project journal

tudelft
faculty of architecture and the built environment
graduation studio 2024~2025
interiors buildings cities
msc3,4 palace: archiving architecture
project journal

liren chu

fig. 3.1.1 sketch, matthijs

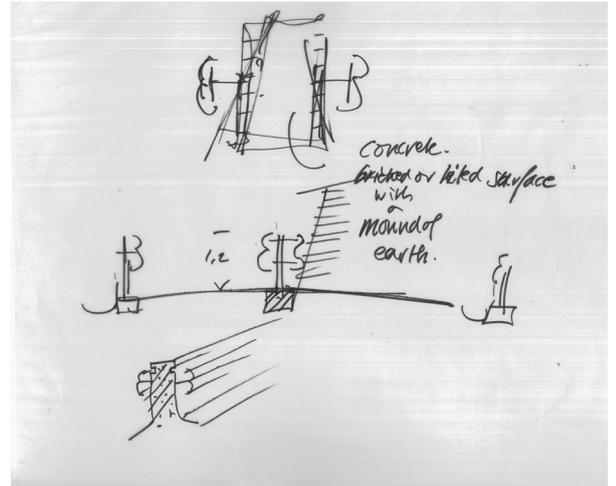
change relation in a potentially positive way
if i work for the vai i dont want to work above the high way
not understand the justification

why lots of money building that not
just a bridge but a combination

you could make an argument you
do all your processing here

actual front edge is the corridor

external bridge of the expo space on bridge
architectural archive material is not same as paintings
shared
a series of exhibition room across the highway

a curious project

almost touch the edge of the road not a reality

give desingel a landscape

more credible as a strategy to build the building closer
to access road where you slow down more like a street

two pieces and something in the middle

whats the quality of sth crossing all
about the drama engineering

now its not like a public corridor 4meters wide

why are you putting a place of a lots of concentra-
tion above the motorway? build an argument for it

why is this a good idea? what do i get?
why is this a best thing to do?

fig. 3.1.2 sketch, matthijs

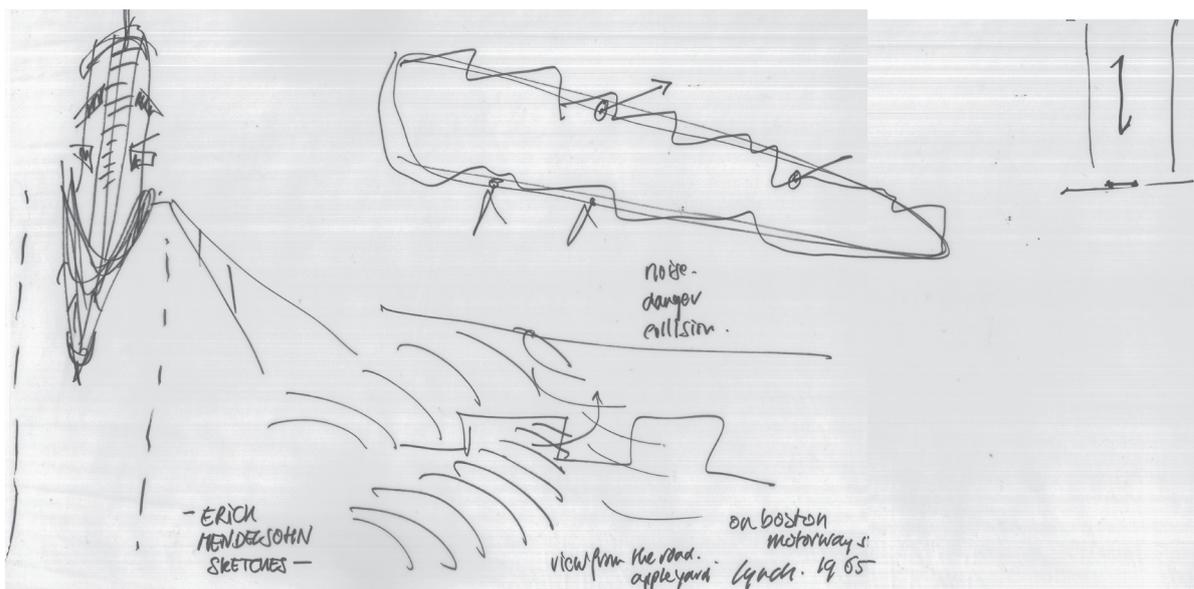
using a combination of two columns would make the entire structure more stable. is the current asymmetrical form necessary?

how to protect the bottom of the building in the highway green belt and integrate it with the lower garden? it can be made with steel-concrete or brick structure as a premise, adding metal guardrails to deflect vehicle collisions, with a surface made of holes mounted with soil for planting greenery.

how should the facade be treated to help isolate noise? should it be stepped back or have a slanted facade? a backward slanted facade would make people look upward. the facade should be made into a complete and unbroken surface, which is beneficial for reflecting noise.

focus on the appearance of the building seen from the highway perspective, referring to mendelsohn's hand-drawn sketches.

fig. 3.2.11 sketches, daniel

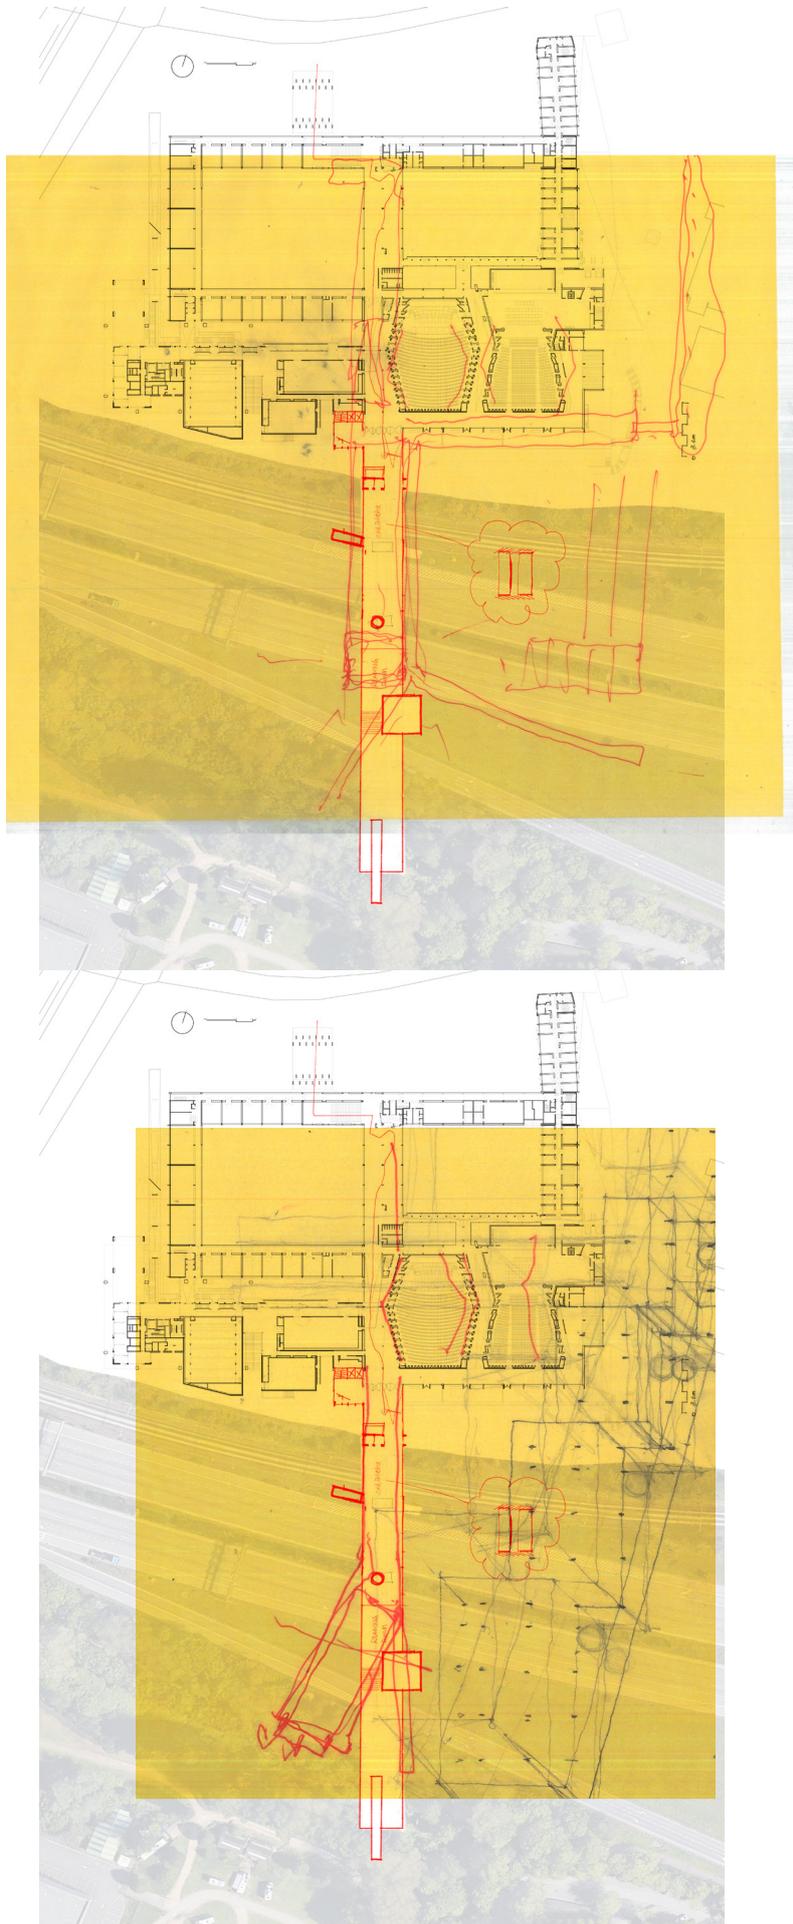
\daniel, susanne
seeing this project reminds me of gigon guyer's **kunstmuseum appenzell**.

i don't quite understand the purpose of this project, but if you want to continue, you should weaken the functional aspect of the bridge, simplify and unify the form. i can see that you are moving in this direction, but it's not enough.

right now, the **form appears to have two distinct parts in architectural language**.

you need to either **simplify the bridge** or **stack the volume on the median into a high-rise to emphasize the bridge**—there must be a clear choice, a definitive answer.

would it be better to go back to the first draft from two months ago?
i've always felt that draft was very clear—perhaps the ending could follow the angular form of bluehall.

fig. 3.2.13 sketch, matthijs

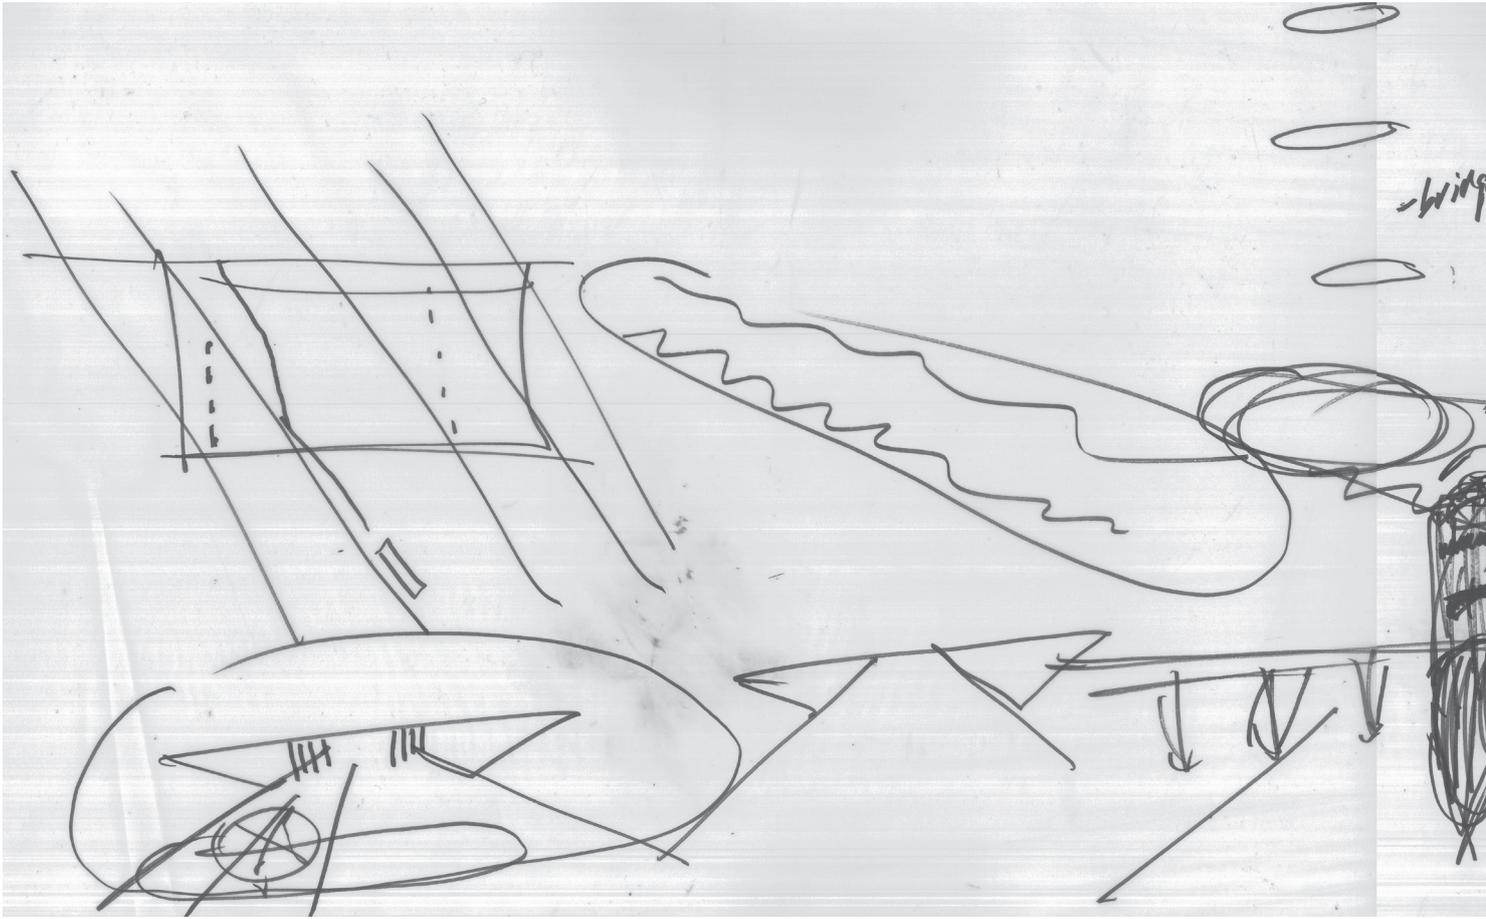
there are many buildings with a triangular footprint. you can check out the flatiron building, the torres de satélite / luis barragán, and the toll stations on highways. looking at your model, these columns are actually too thin. they should all have a concrete base, and these bases should have a taper.

this enclosed site on the highway section gives me the opportunity to create an alien-like building. i am imagining a sculptural structure, like a bunker from the atlantic war era.

fig. 3.3.8 sketch, matthijs

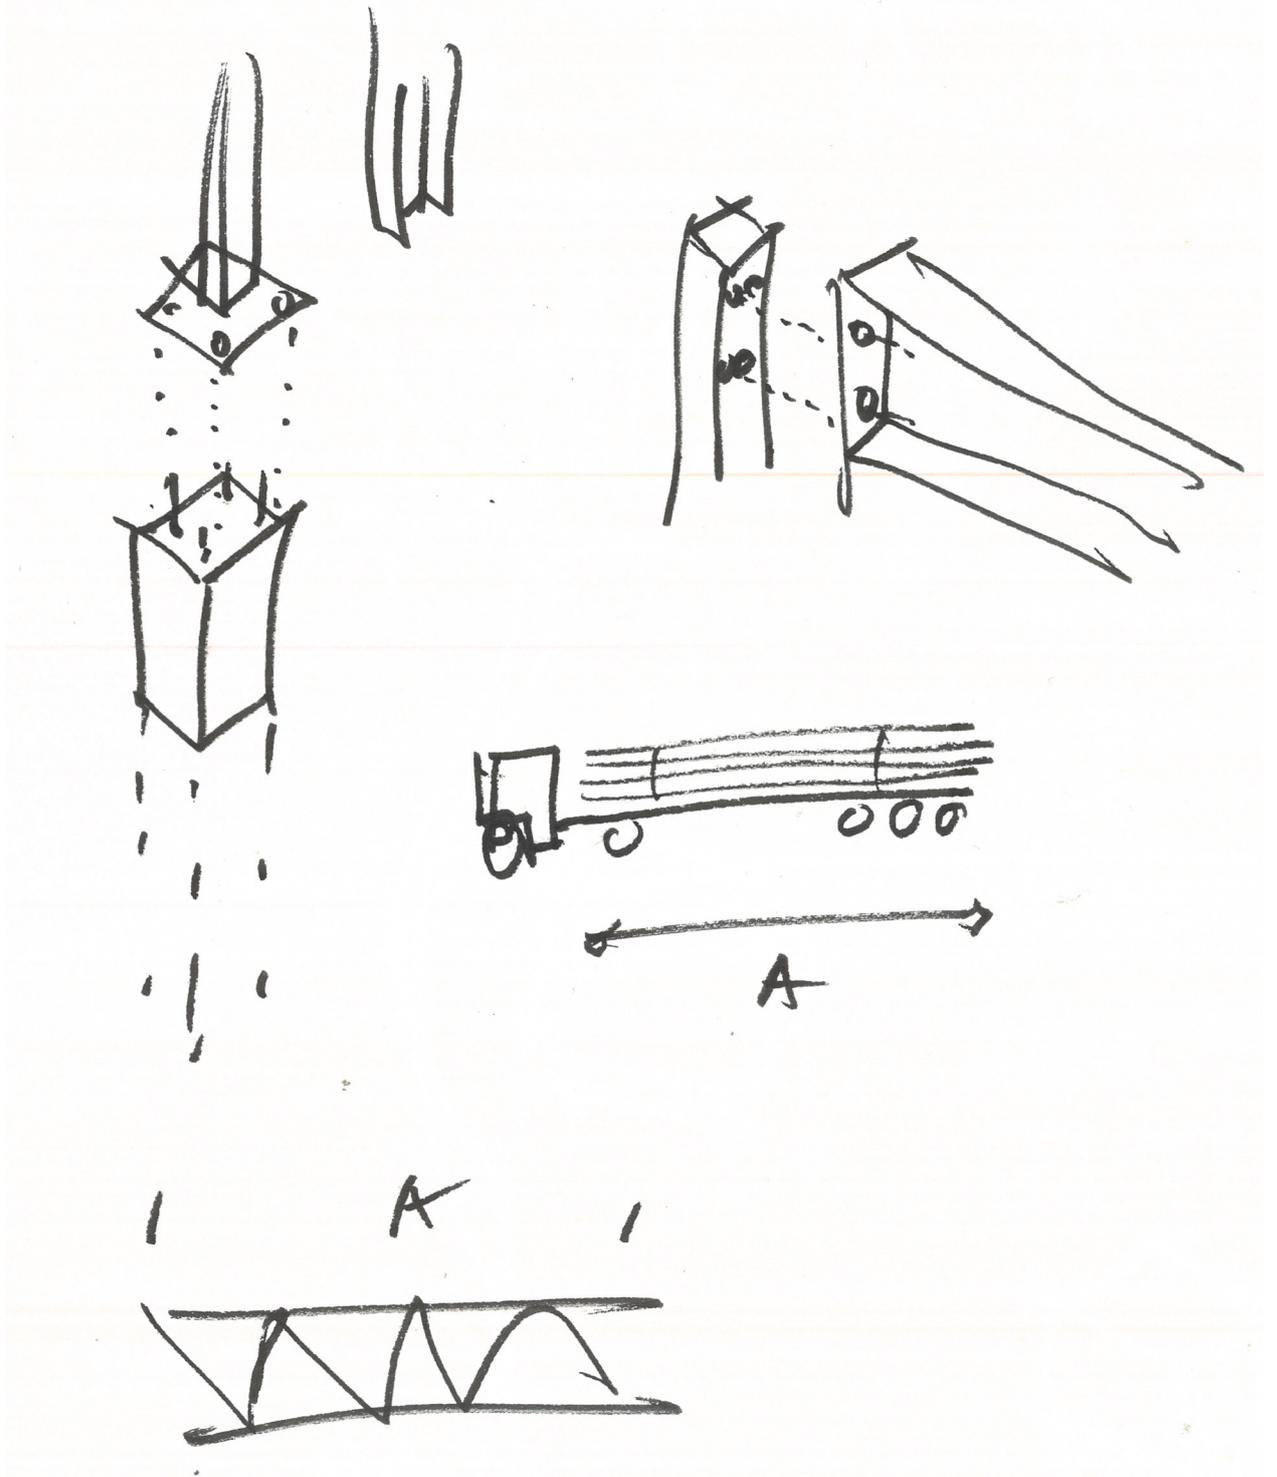
think about why this building is positioned here—could it be moved further back?
the wall section plan needs to be refined, considering structural typologies

fig. 3.4.13 sketch, matthijs

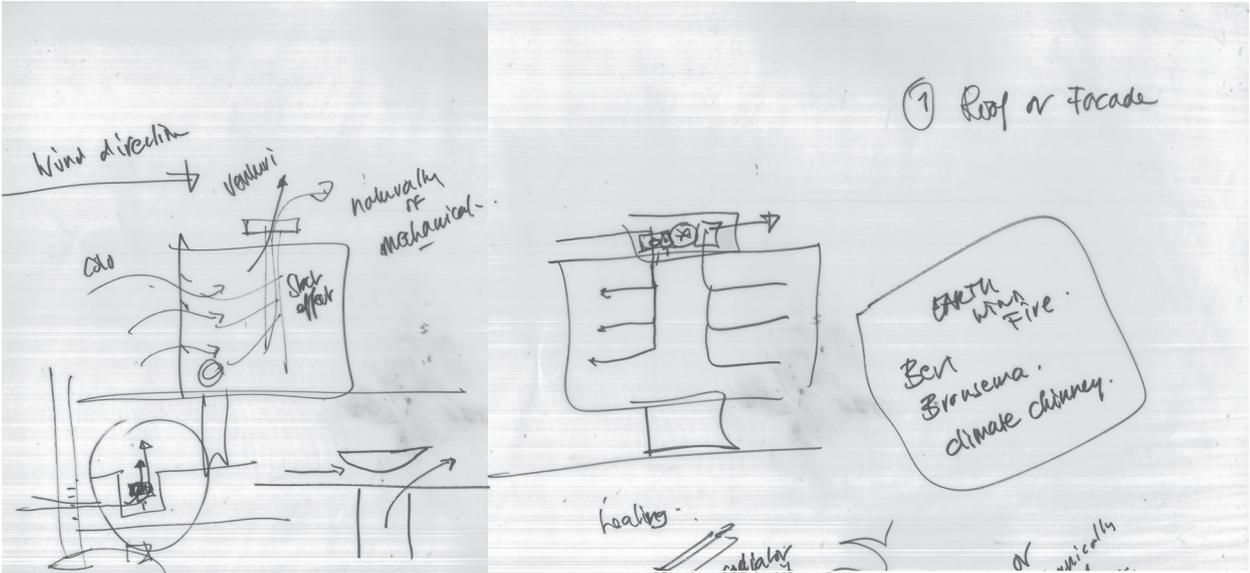
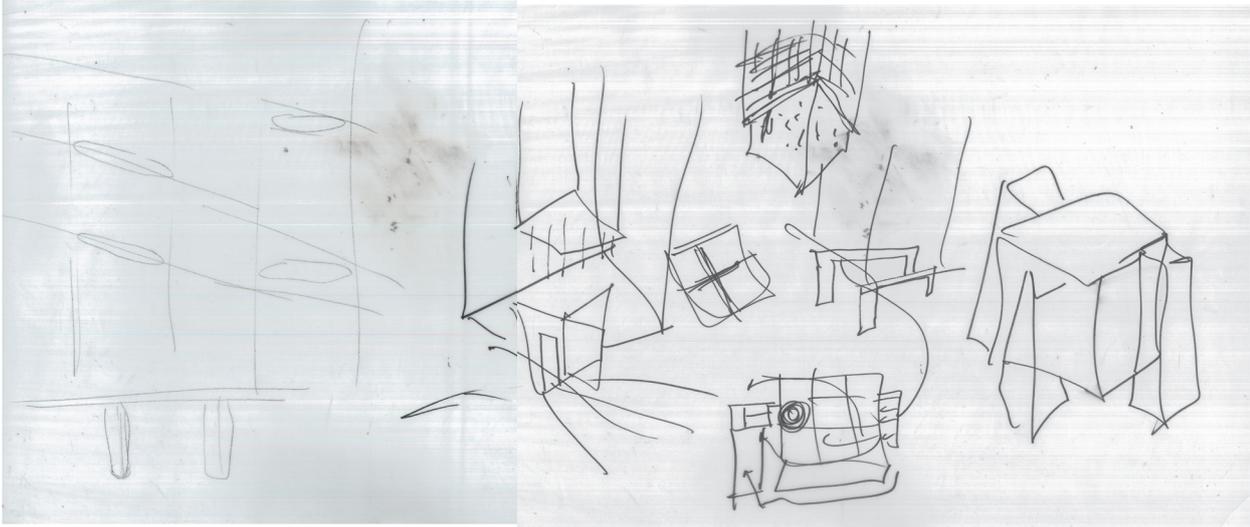
: the linear building serves as the backbone of the entire site, connecting four blocks and functioning as the infrastructural foundation for the future growth of the archive and the park.

this concept needs to be conveyed in the master plan.

which part of the building will be modeled?
a fragment will suffice—specifically, the four key connection points that need to be expressed

as long as keep two options for fire escape
how to protect the staircase?
prevent smoke, door hinge . if you put glass in it, difficult to stand 1 hour when fire comes.
so you need two staircases, one architectural one fire escape.

how to design ventilation system?
natural/mechanical
venturi stack effect
radiator in the floor heating
the input air flow over it

ventilation is usually mechanically done with the same system air is suck out and breezed in.
think about the heating radiator or floor heating

centralized or decentralized
heat exchange makes things more sustainable but passive ventilation is more

fig. 3.5.6 plan sketch, jurjen

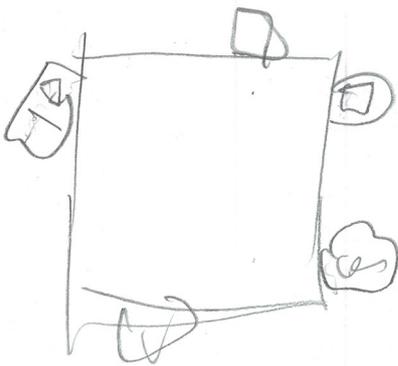
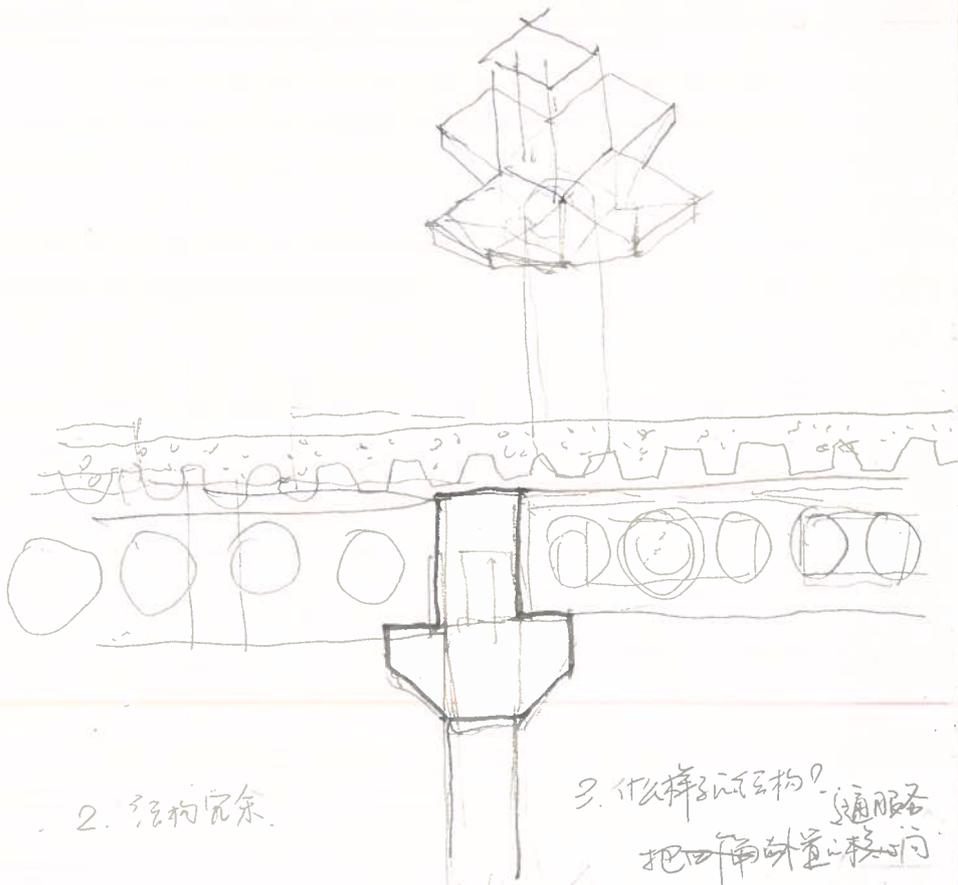
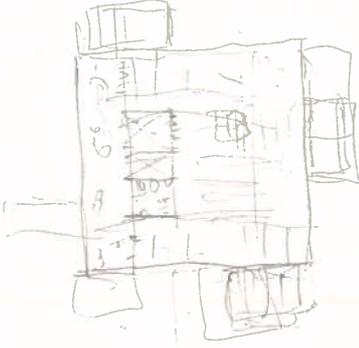
the design needs to be simplified. the rotating plane scheme will cause circulation issues.

you have two options: one is to let the archive occupy the entire square floor plan, with other functions placed externally as a core, allowing the workspace to flexibly exist on any facade. the other is to place the workspace entirely on the top floor.
